DESIGN #	DRAWN BY #	DART AEROSPACE LTD HAWKESBURY, ONTARIO, CANADA	
CHECKED CP	APPROVED #	DRAWING NO. DSI 9192	REV. A SHEET 1 OF 2
DATE 00.10.24		TITLE ADD D350-607-043/-044	SCALE NTS
A	00.10.24	NEW ISSUE

# **DART SERVICE INSTRUCTION**

TO AMEND INSTALLATION DRAWING D350-607 REV. E  
REF. CANADIAN STC SH94-14 & FAA STC SR00213NY

## D350-607-043 HELI-UTILITY-BASKET

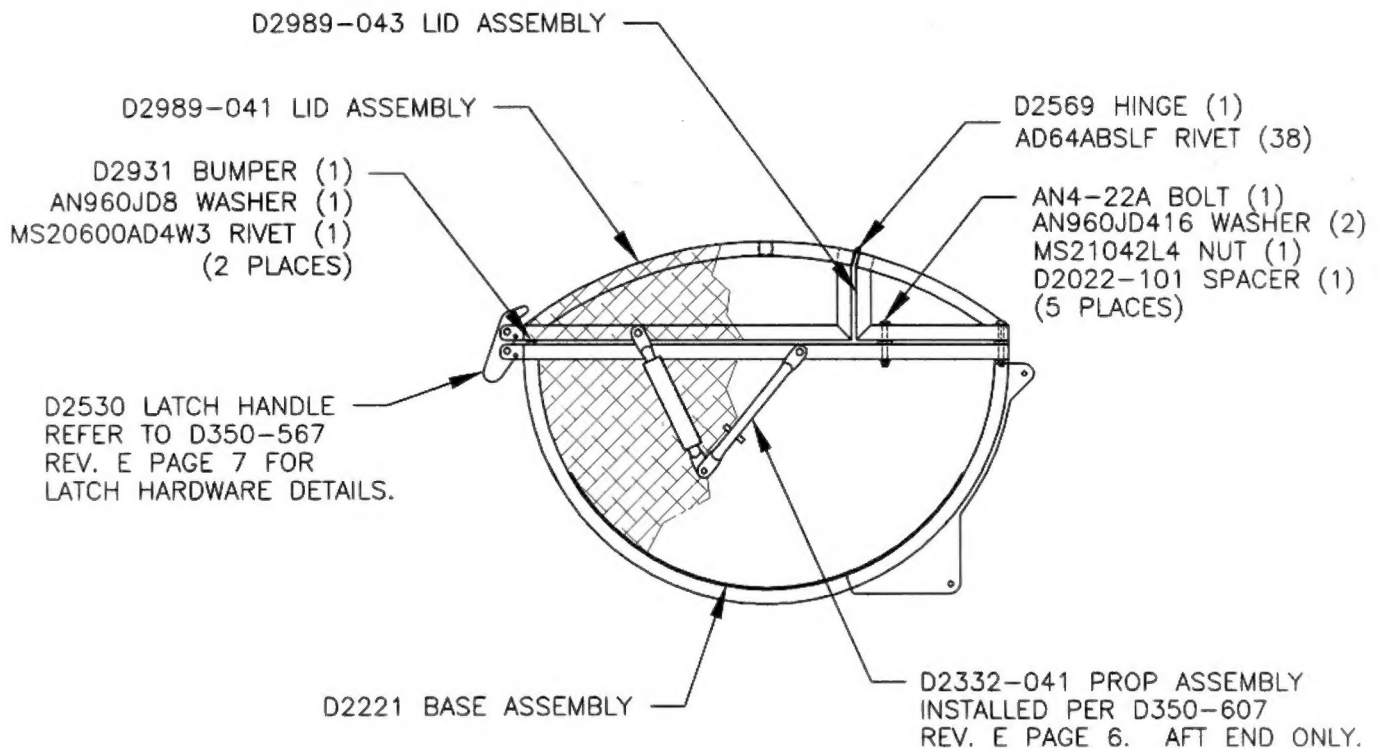
FOR COMPATABILITY WITH EUROCOPTER CANADA "SQUIRREL CHEEKS", INSTALL D350-607-043 INSTEAD OF D350-607-041. D350-607-043 CAN BE CONVERTED INTO A D350-607-044 BY MOVING THE D2332-041 PROP ARM ASSEMBLY TO THE AFT END OF THE BASKET AND SWITCHING THE FWD AND AFT MOUNTING BRACKETS.

(SECTION C-C OF D350-607 REV E)  
INSTALL PER PAGES 3-5 OF D350-607 REV. E
